To:	Flood Control District of Maricopa County  2801 West Durango Street Phoenix, Arizona	From:	Stantec Consulting Inc. Stephanie Gerlach, PE 8211 South 48 <sup>th</sup> street Phoenix, AZ
File:	Stantec # 181300034	Date:	April 24, 2009

### **RE: Gila River Bank Stabilization Pre-design Baseline Condition Summary**

**Response to Comments**

Figure No.  
**Figure 2**

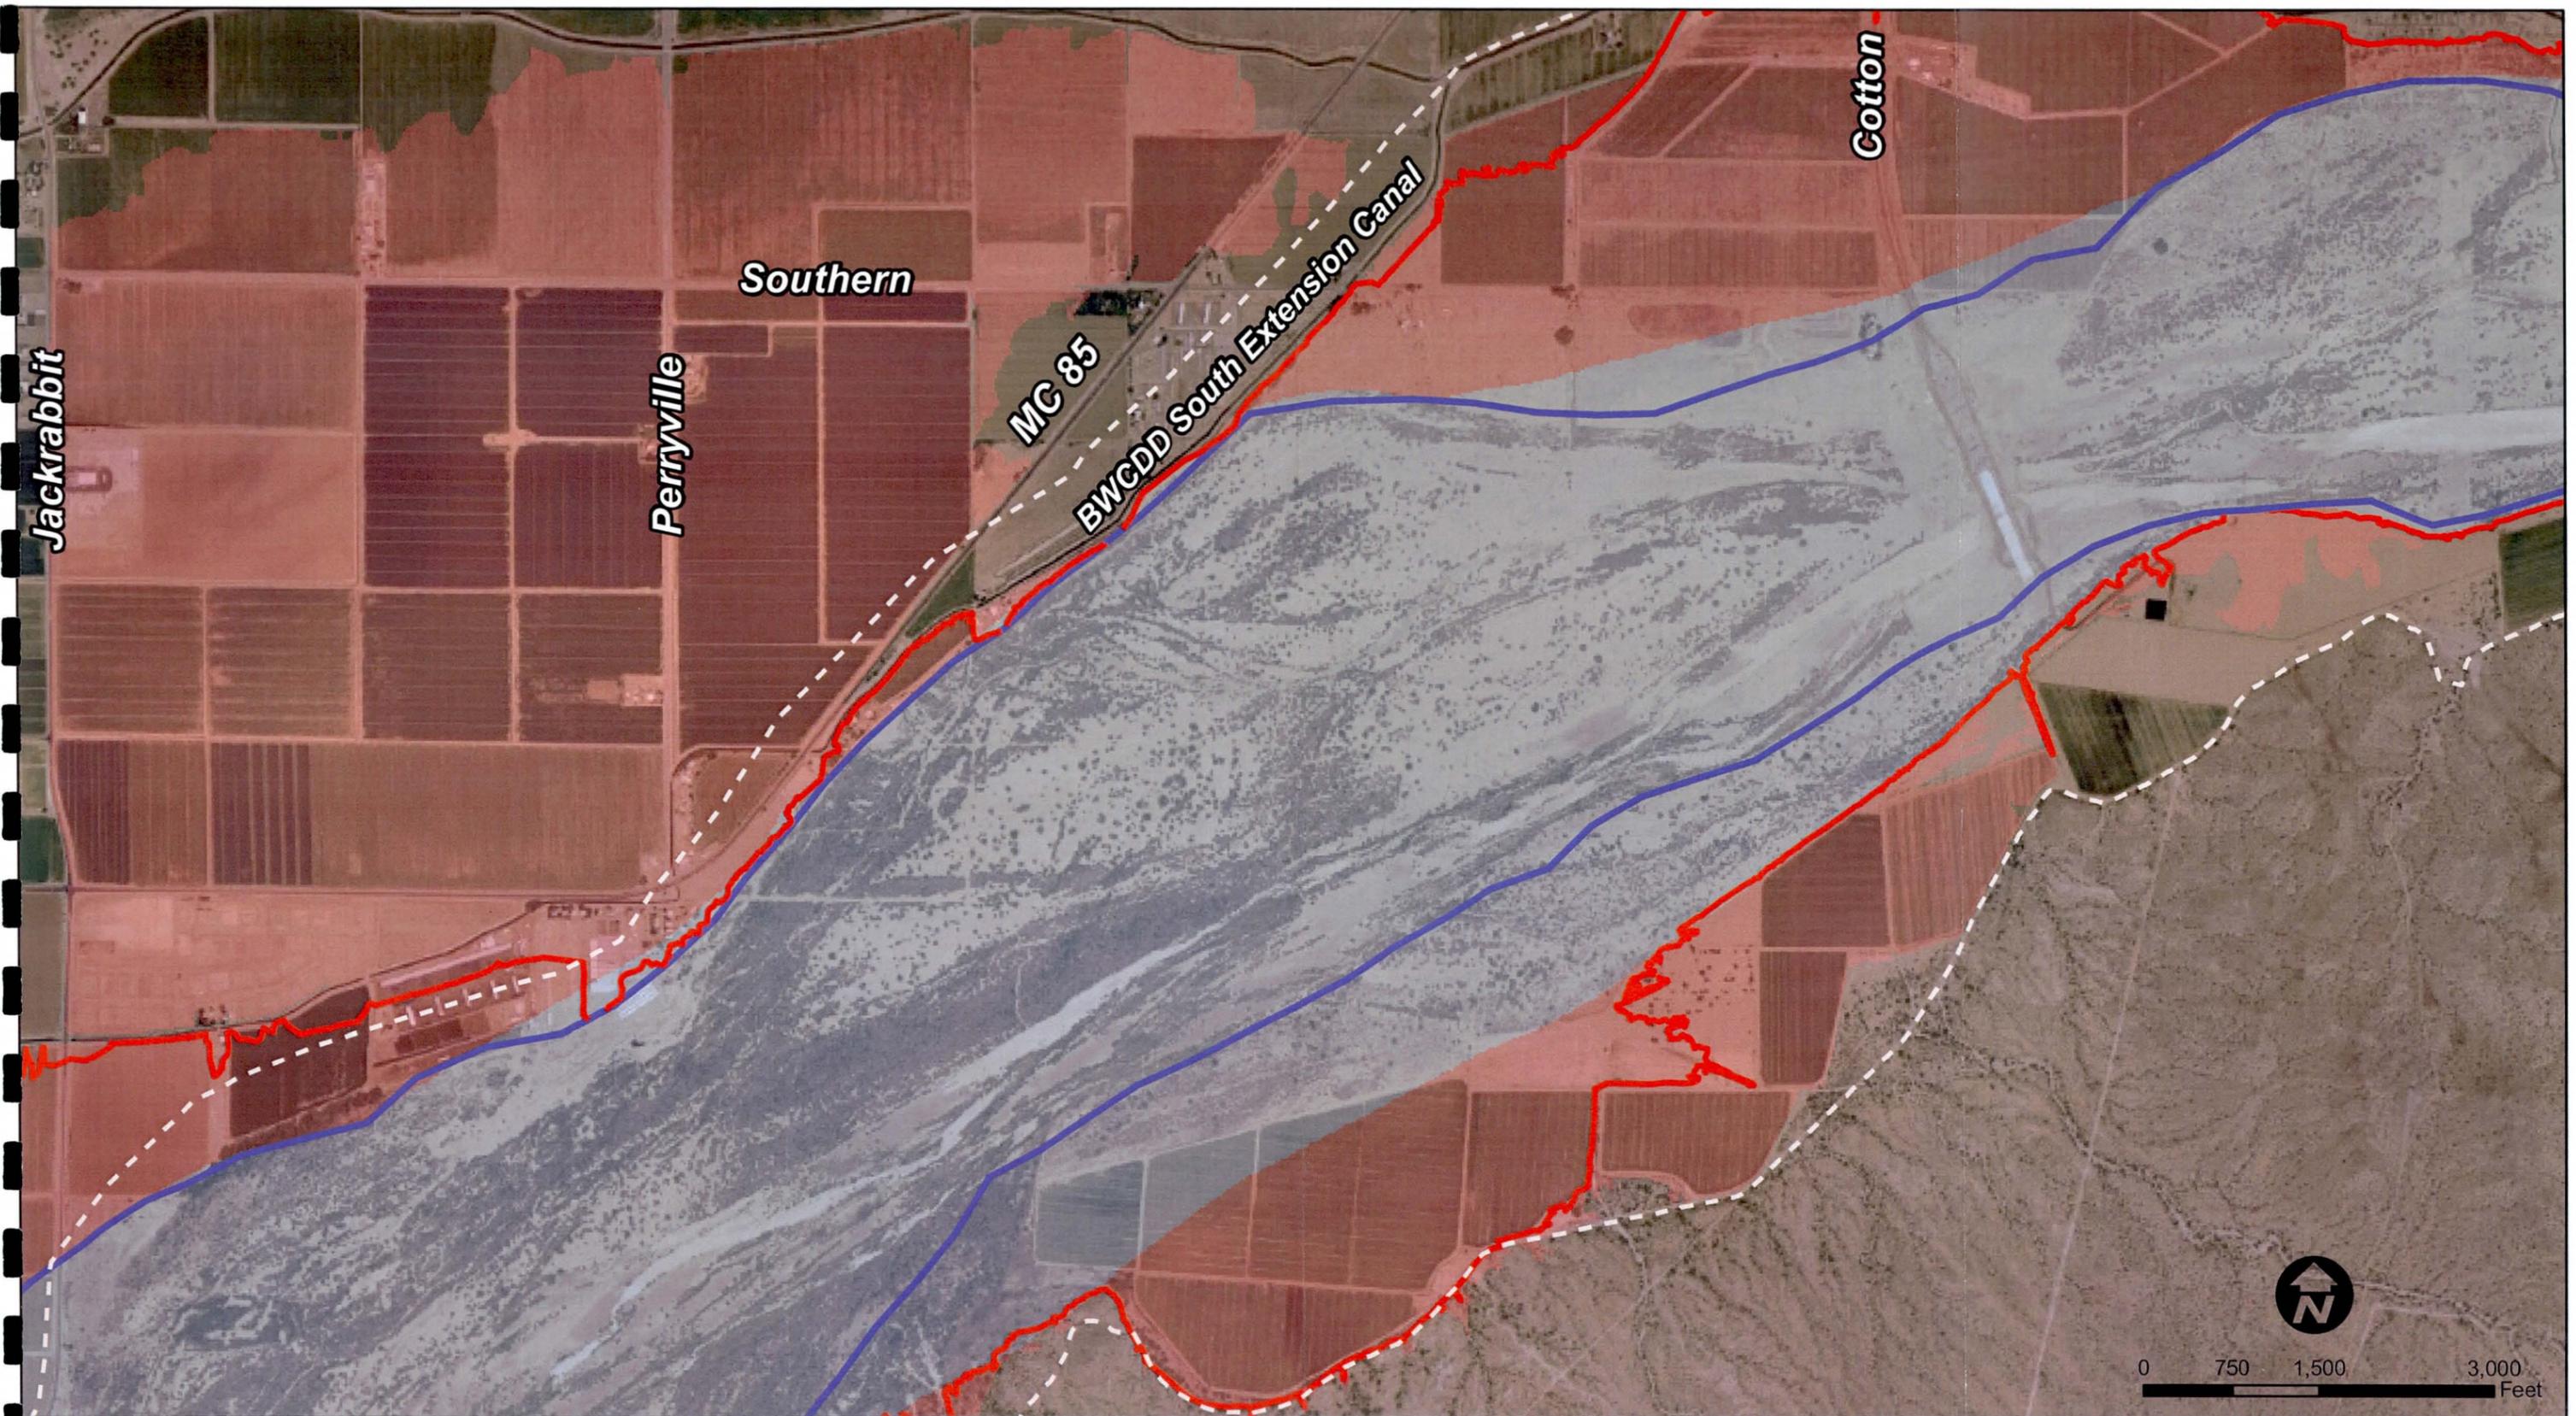
14		D. Farar	The section on Impacts per jurisdictional boundaries needs to be expanded to provide land uses for each property (see comment 2 for suggested table documentation).	Additional information was added to the memo.
15		D. Farar	The historic flood and erosion value of damages was not included as a part of the memo. This information would be helpful for Goodyear's consideration of the project.	Unfortunately BWCCD does not have any records, such as photos or repair costs, of the damage from various flood events. Costs from the CIP memo were added.
16		J. Pokorski	I suggest removing the Erosion Hazard Boundary maps. The presence of the old floodplain is confusing and the EHZ appears on other maps.	Okay
